#### REMARKS

Claims 1-21 are pending in the present Application and have been rejected by the Examiner. The issues in the Office Action dated October 9, 1997, are:

Figure 1.

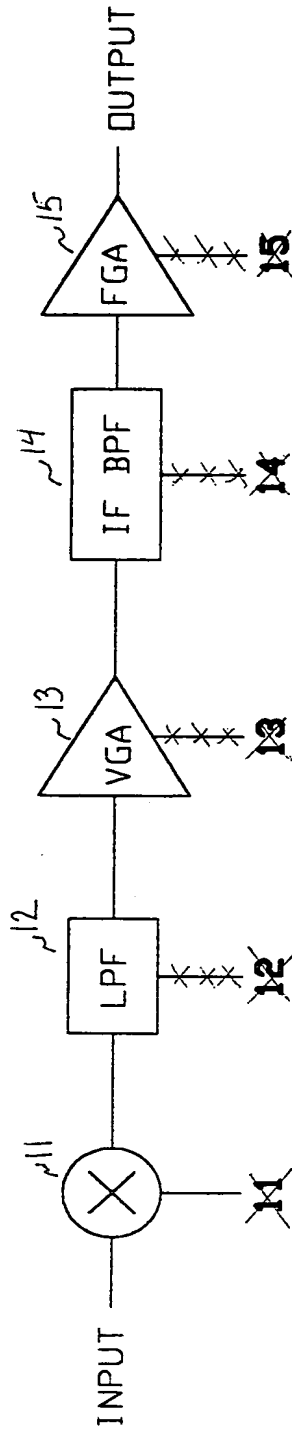
The Examiner has objected to the drawings as unclear as to whether the reference lines are intended to be inputs to the various circuit components.

Applicant has submitted amended drawings to distinguish the reference lines from the circuit inputs. Corrections to the amended drawings are indicated in red ink as required under M.P.E.P. § 608.02(v). Applicant will submit formal drawings upon allowance of the present application. A copy of the amended drawings have been forwarded to the Official Draftsman under separate letter. The amendments to the drawings add no new matter to the application.
